# Shoalhaven Starches Expansion Modification 19

State Significant Development Modification Assessment  
(06\_0228-Mod-19)

Subtitle: State Significant Development Modification Assessment Report

**Figure 7 | Proposed Additional Ethanol Storage Tanks**

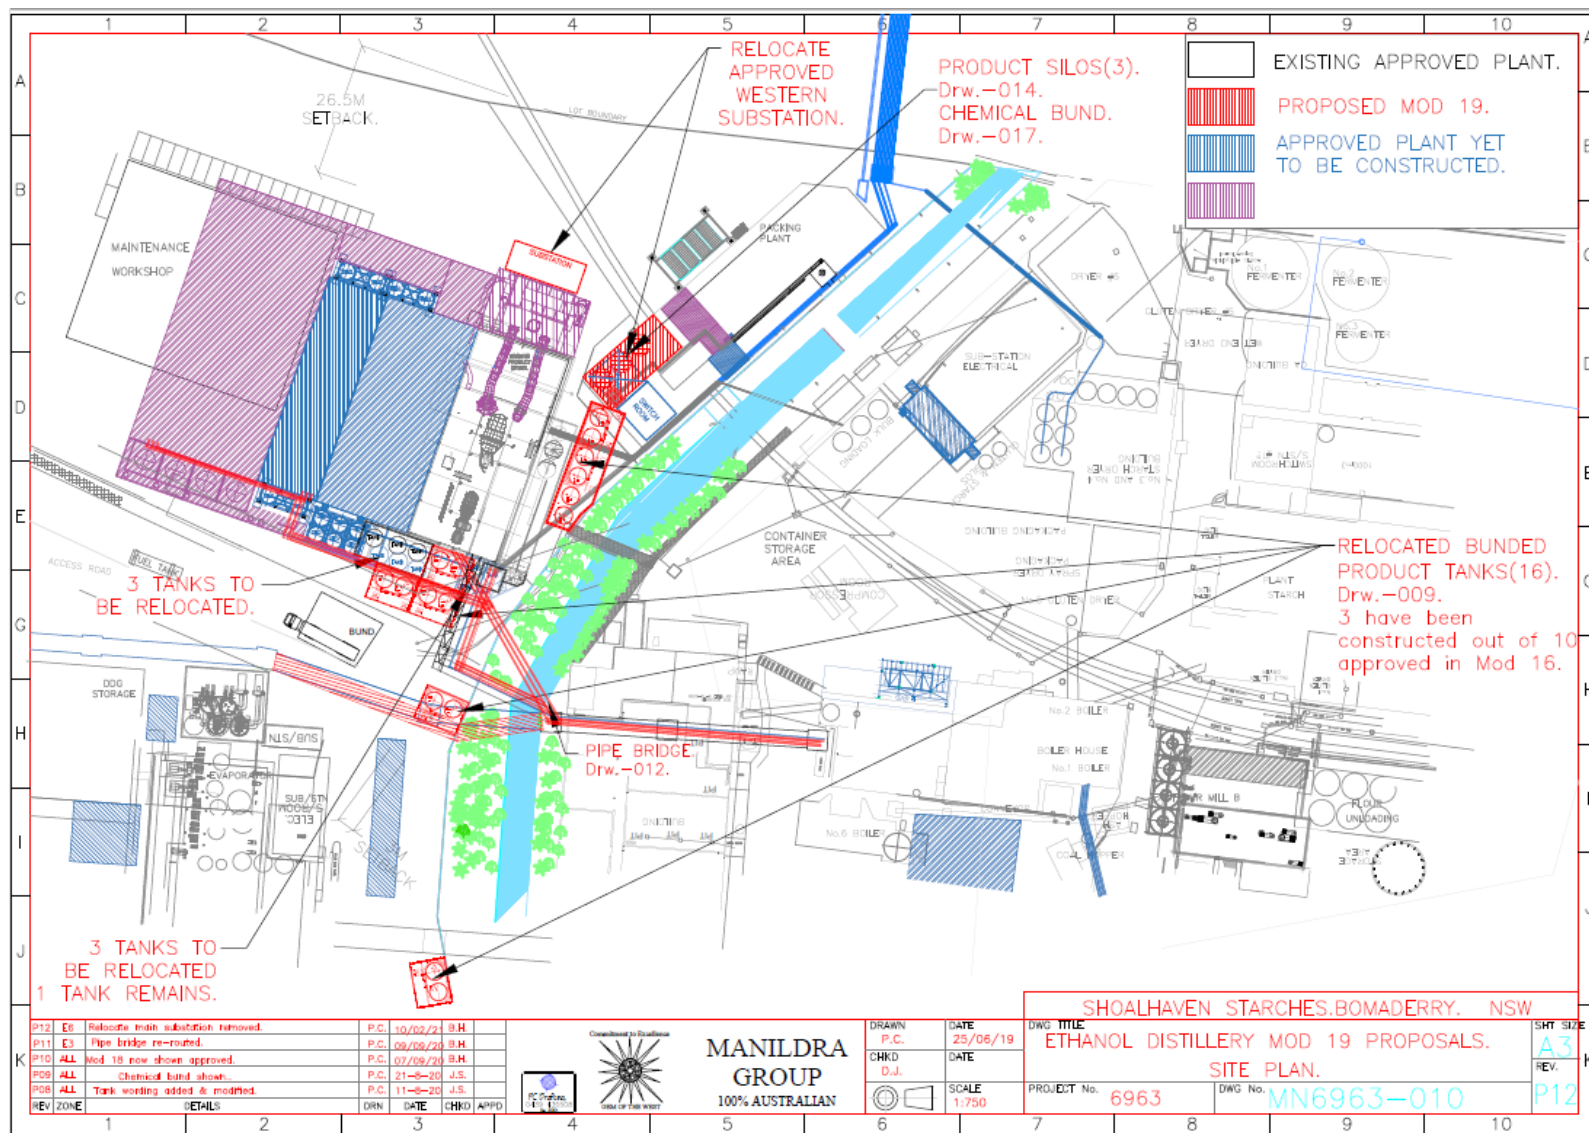
**EPA** did not object to the modification but provided comments on the Noise Impact Assessment (NIA) and requested the NIA to be amended. The EPA additionally recommended the implementation of a condition requiring floating roofs to be installed to the three proposed ethanol storage tanks.

The EPA initially recommended a condition requiring the Applicant to install floating roofs to the new ethanol storage tanks to manage volatile organic compound (VOC) emissions as a best practice method for mitigating vapours in liquid storage tanks. However, the Applicant raised concern with this requirement noting that floating roofs have the potential to contaminate the ethanol products stored in the tanks and the ethanol product would subsequently not be able to comply with relevant food safety standards.

Following further discussion between the Applicant and the EPA, it was agreed that while this approach represents best practice, it is not specifically required to address emission issues with this modification. Instead, a plan detailing measures and practices to minimise and manage VOC emissions was considered reasonable and has been supported by the EPA to be included as a condition of consent.

The Department recommends the inclusion of a condition requiring the Applicant to prepare a VOC emissions management plan to manage potential emissions associated with the proposed ethanol storage tanks. The Department's assessment concludes the modifications to the Shoalhaven Starches facility will not result in significant air quality impacts and that any residual issues can be effectively managed through the existing EPL and recommended and existing conditions of consent.
